Subject: Purge timer change

Our standard purge timer part number 012425 has become obsolete, and is being replaced by part number 253100. See page 2 of the bulletin for wiring changes.

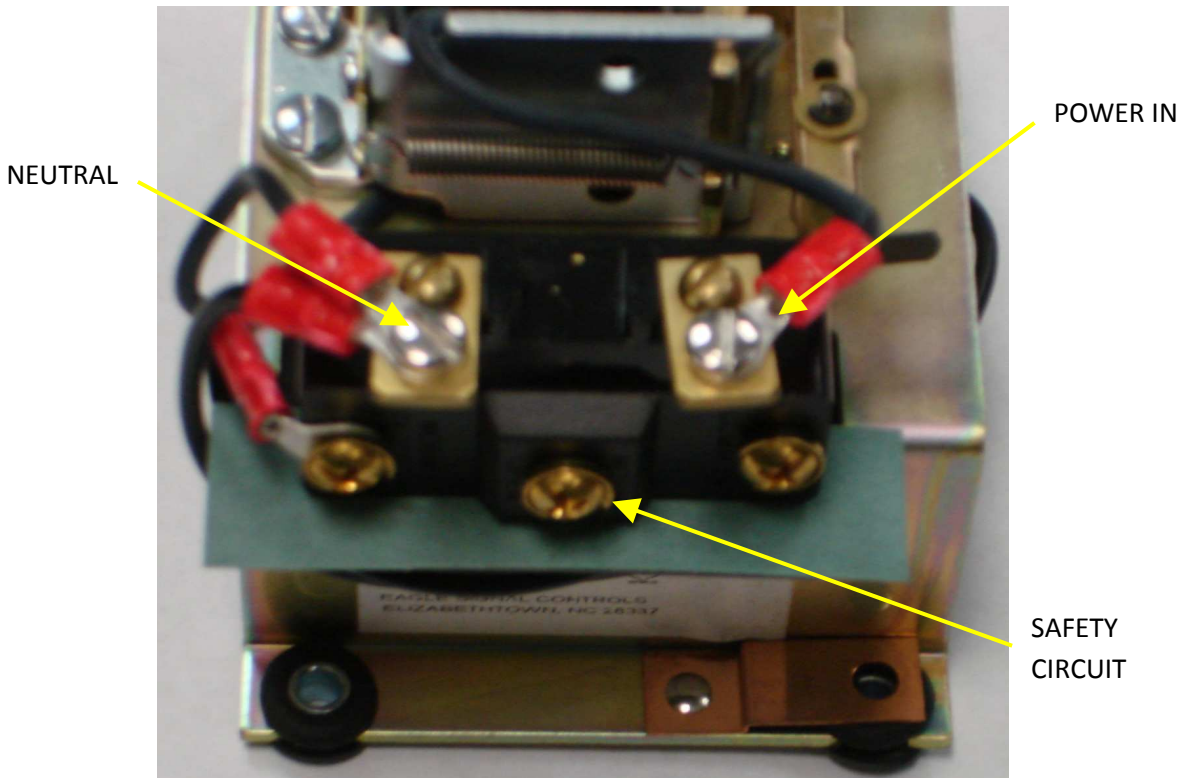
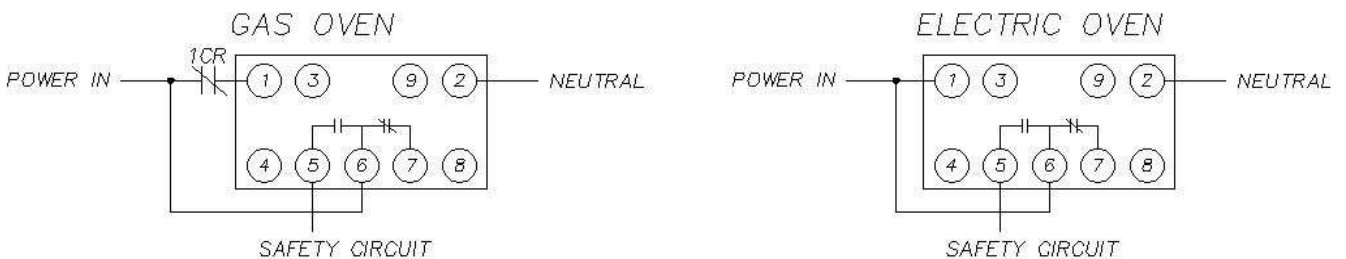
Part number 012425

Part number 253100

Timer 012425 wiring

Typical timer 253100 wiring

Note: Add jumper between terminal 1 and 6 for electric ovens.
